本書には、以下に示す誤りがございました。お詫びして訂正いたします。

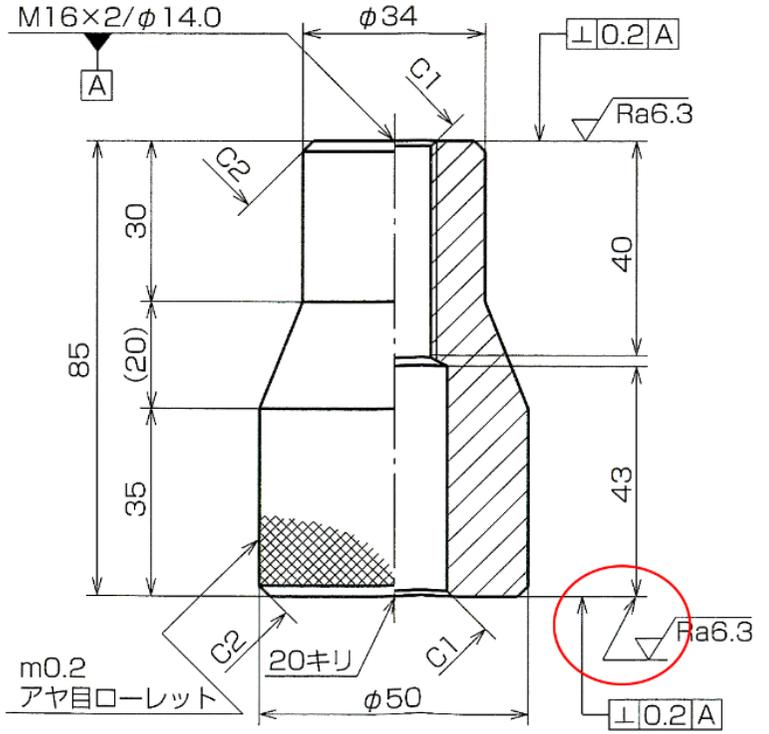
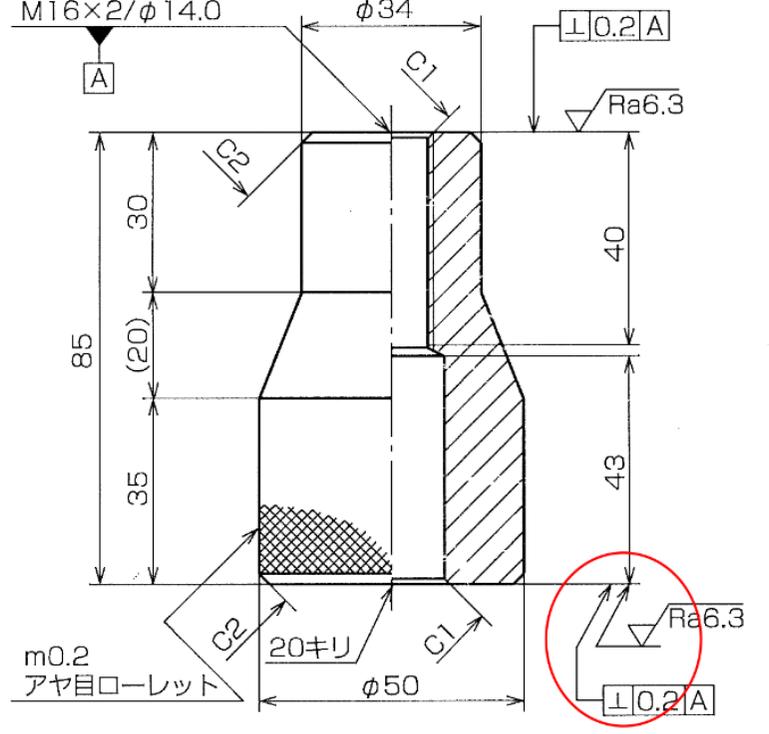
箇所	誤	正
製図例2-2 左下	<p>Technical drawing of a rectangular flange with a central hole and four mounting holes. The drawing shows surface finish symbols (Ra1.6, Ra6.3) and geometric tolerances (C1, $\phi 80$ H7, $\phi 100$ H7, $\phi 0.01$ B, $\phi 0.01$ C). Two Ra6.3 symbols at the bottom are circled in red.</p>	<p>Identical technical drawing to the '誤' (Incorrect) version, but the two Ra6.3 symbols at the bottom are not circled in red.</p>
製図例2-3 左上	<p>Technical drawing of a rectangular flange with a central hole, four mounting holes, and a central raised section. The drawing shows surface finish symbols (Ra1.6, Ra6.3, Ra50, Ra25, Ra9.3) and geometric tolerances (C1, $\phi 80$ H7, $\phi 72$ H7, $\phi 100$ H7, $\phi 120$, $\phi 0.01$ B, $\phi 0.01$ C, $\phi 0.01$ D). Two Ra6.3 symbols at the bottom are circled in red.</p>	<p>Identical technical drawing to the '誤' (Incorrect) version, but the two Ra6.3 symbols at the bottom are not circled in red.</p>

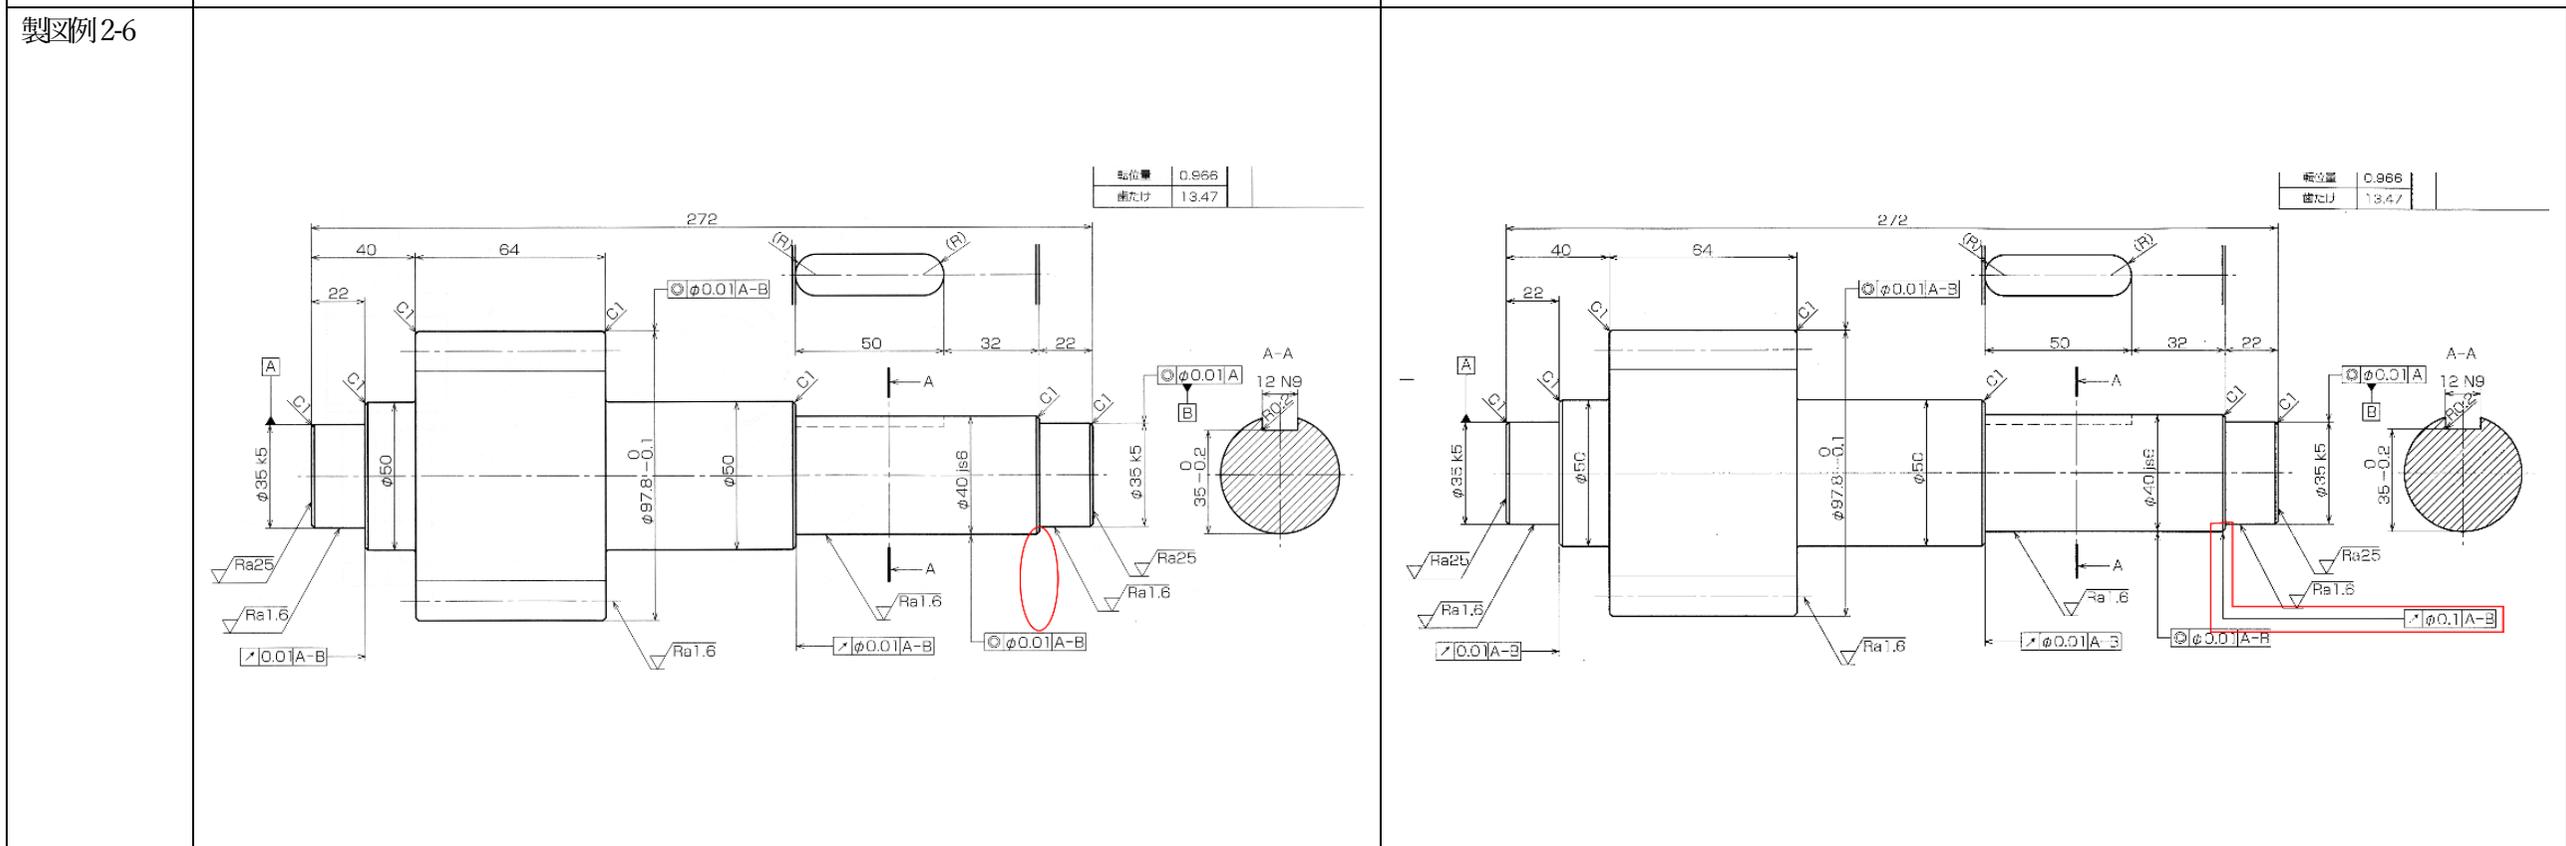
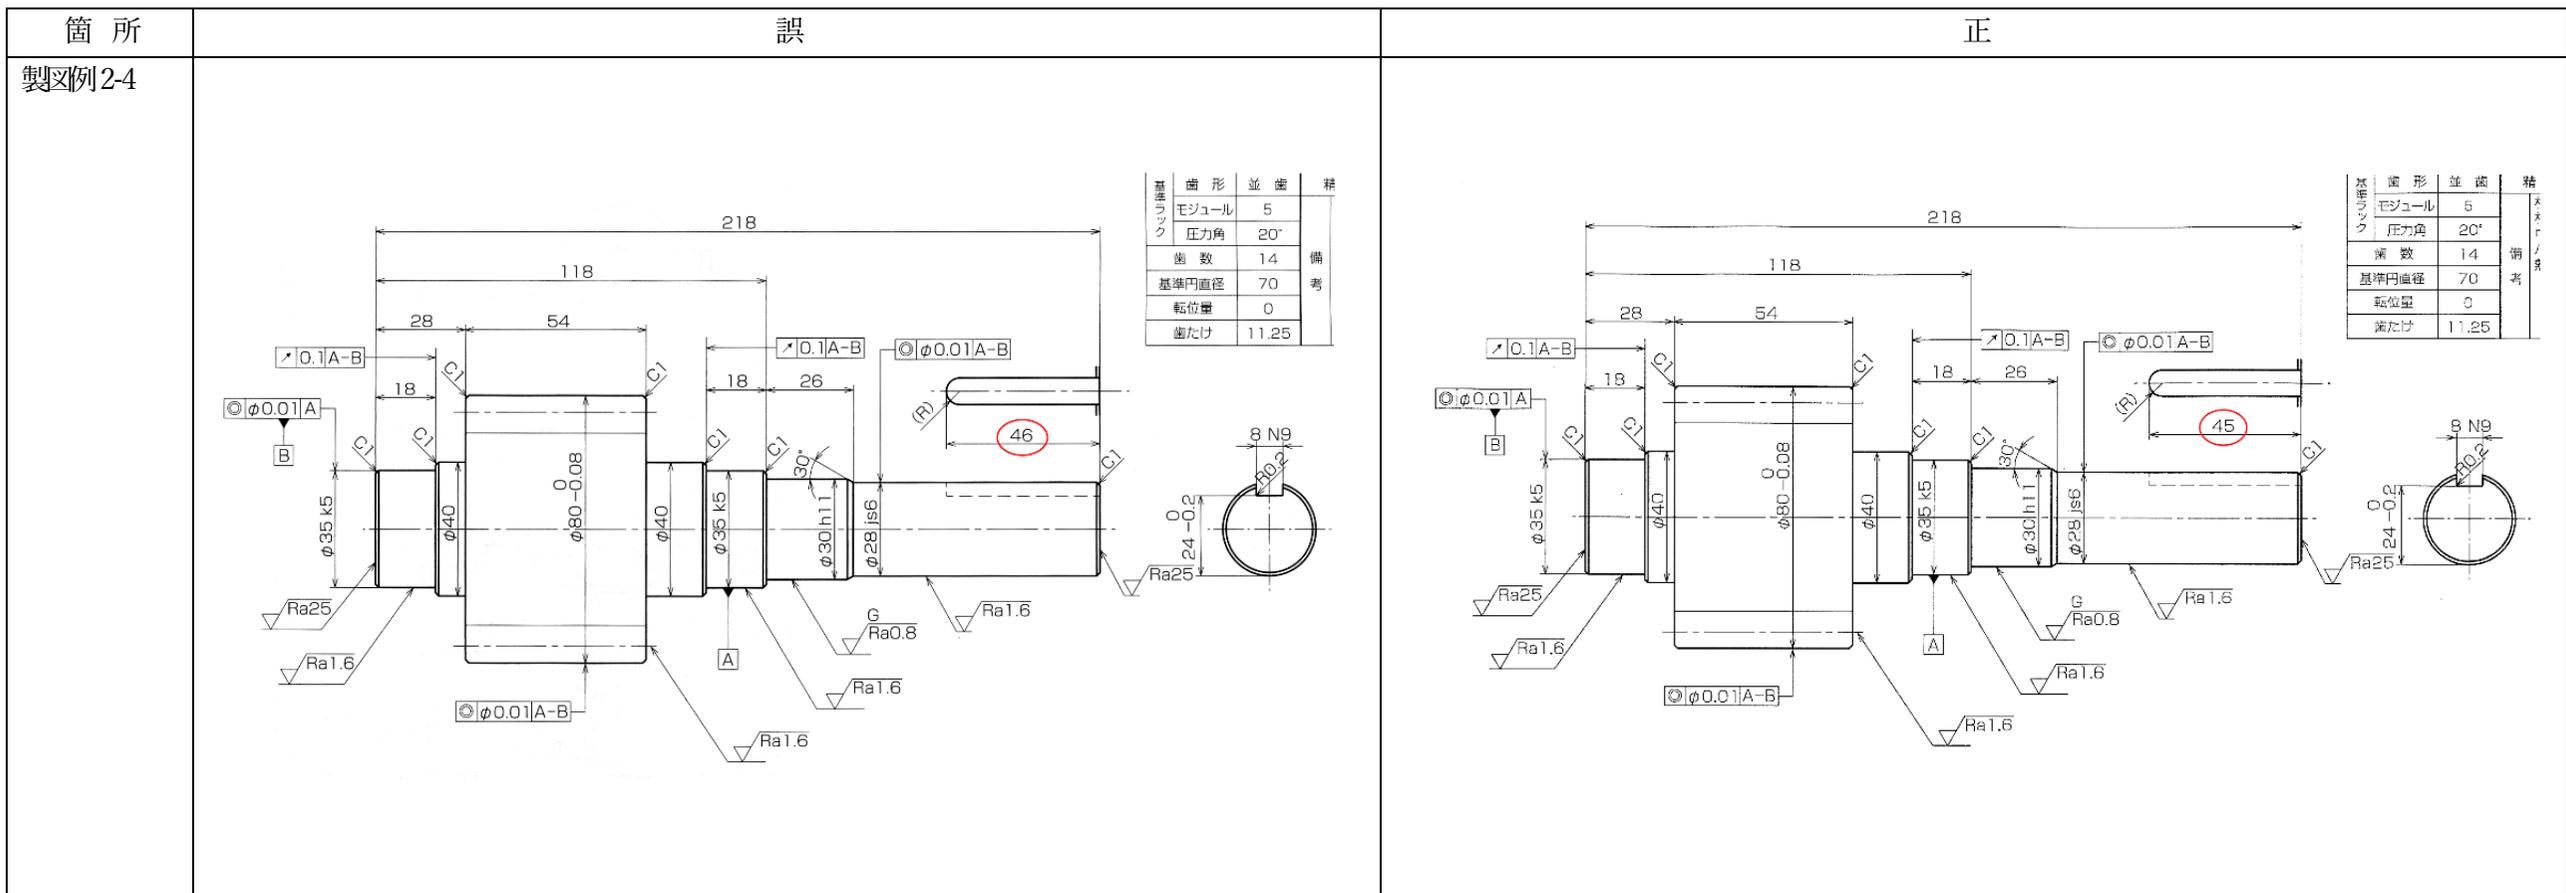
箇所	誤	正
製図例3-9 左上 ⑧	<p> $\sqrt{Ra25}$ ($\sqrt{Ra6.3}$) (40) 10 20 10 20 20 67 7 2.8 7 R5 R1 12.5 $20 \begin{smallmatrix} 0 \\ -0.2 \end{smallmatrix}$ $4 \times 10.6 \pm U$ $Ra6.3$ </p>	<p> $\sqrt{Ra25}$ ($\sqrt{Ra6.3}$) (40) 10 20 10 20 20 67 7 2.8 7 R5 R1 12.5 $20 \begin{smallmatrix} 0 \\ -0.2 \end{smallmatrix}$ $4 \times \phi 10.6$ $Ra6.3$ </p>
製図例3-9 右 ⑩	<p> $\sqrt{Ra25}$ ($\sqrt{Ra6.3}$) (40) 10 20 10 20 20 15 70 3 1.4 M8 (丸先) $2 \times 10.6 \pm U$ $Ra6.3$ 42 </p>	<p> $\sqrt{Ra25}$ ($\sqrt{Ra6.3}$) (40) 10 20 10 20 20 15 70 3 1.4 M8 (丸先) $2 \times \phi 10.6$ $Ra6.3$ 42 </p>

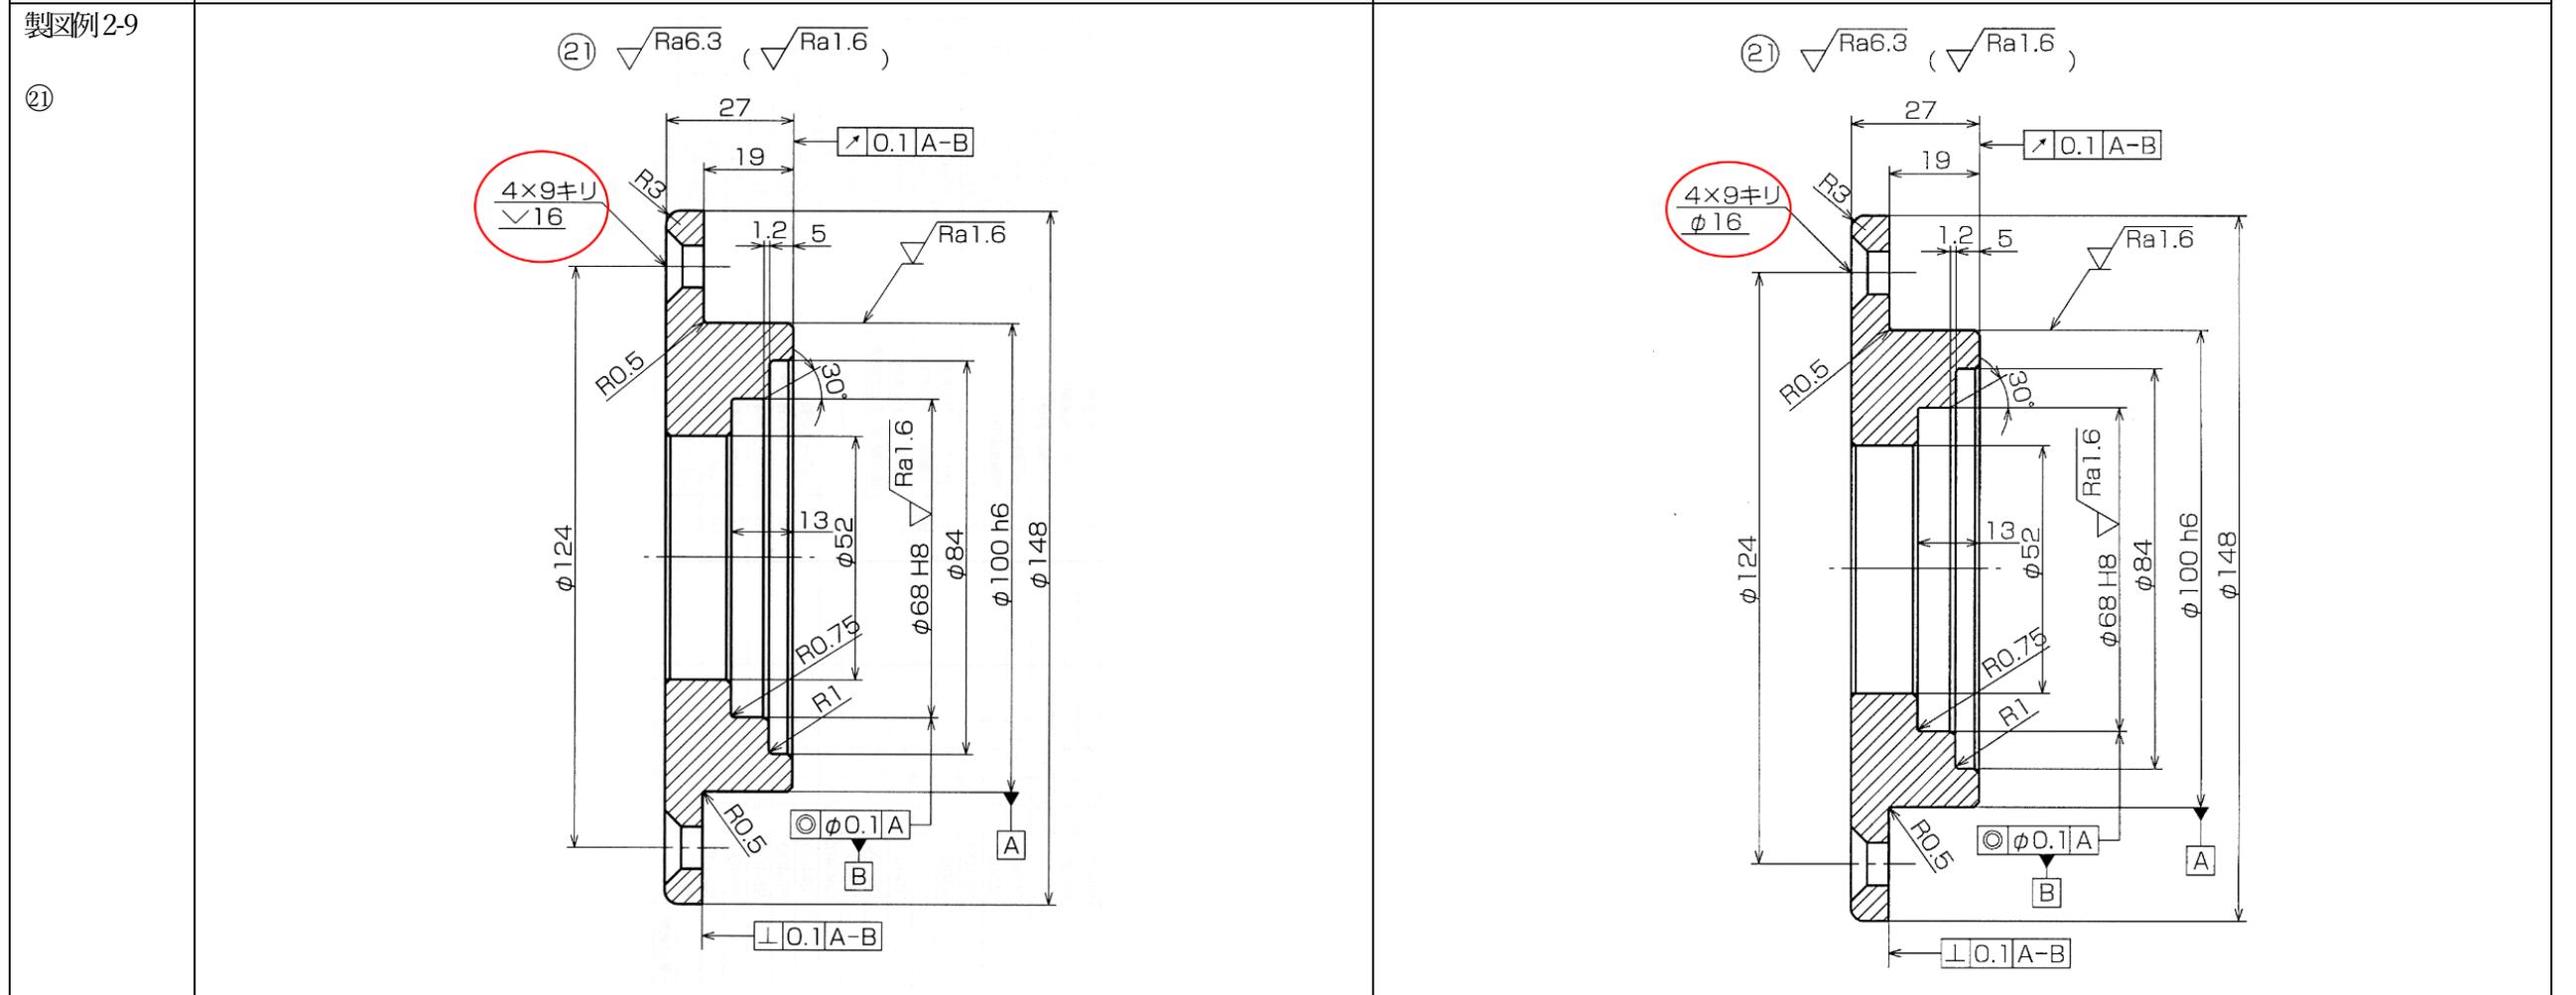
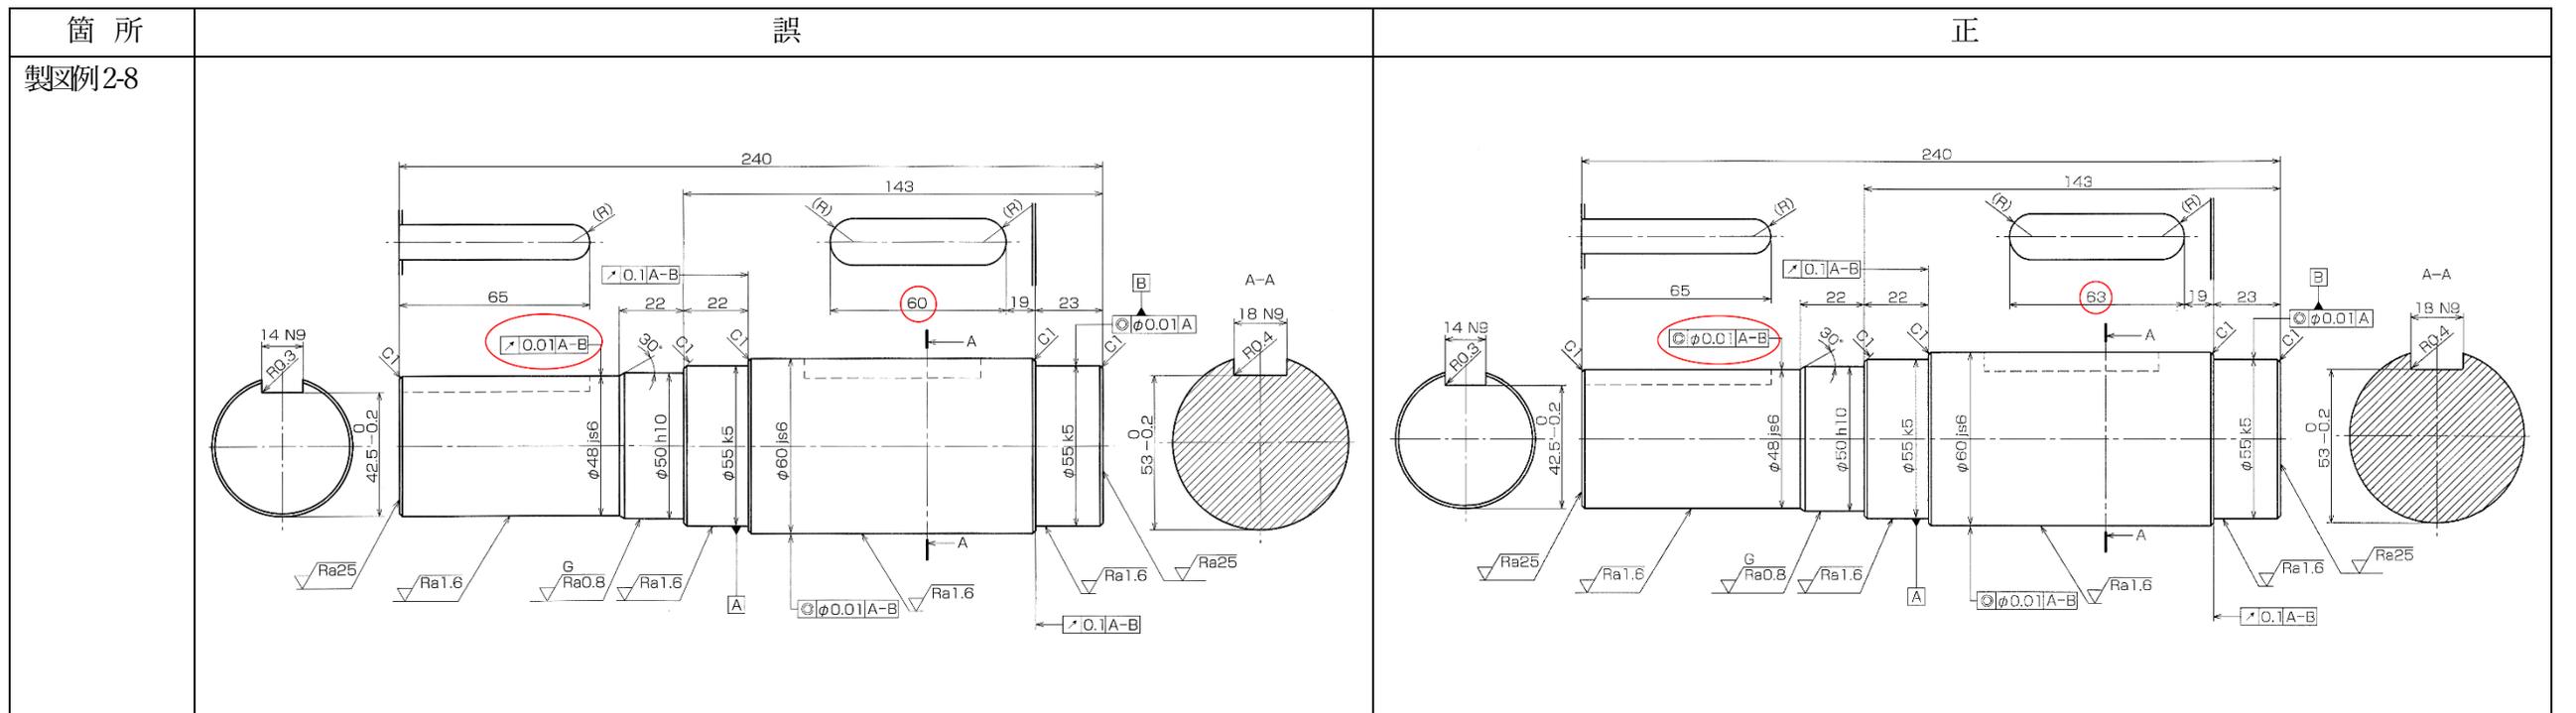
箇所	誤	正
製図例3-12 右 ⑯	 <p>Technical drawing of a part with two holes. Dimensions: 60 (total width), 34 (hole spacing), 20 (hole diameter), 10 (hole offset), 50 (neck length), 30 (bottom hole diameter), 100 (total height), 50 (bottom hole diameter). Surface finish: Ra6.3. Hole specification: 2×12\neqU. Section A-A is indicated.</p>	 <p>Technical drawing of the same part. Dimensions are identical to the error drawing. Hole specification: 2×ϕ12. Surface finish: Ra6.3. Section A-A is indicated.</p>
製図例3-13 左 ⑰	 <p>Technical drawing of a part with a chamfered edge. Dimensions: 79 (total width), 12 (chamfer width), 100 (total height), 60 (height to chamfer), 20 (chamfer height), 28 (chamfer offset), 32 (chamfer length), 9 (chamfer thickness), 16 (chamfer radius), 9 (chamfer radius), 0.5 (chamfer tolerance). Surface finish: Ra6.3. Chamfer specification: 2×14\neqU. Section A-A is indicated.</p>	 <p>Technical drawing of the same part. Dimensions are identical to the error drawing. Chamfer specification: 2×14\neqU. Surface finish: Ra6.3. Section A-A is indicated.</p>
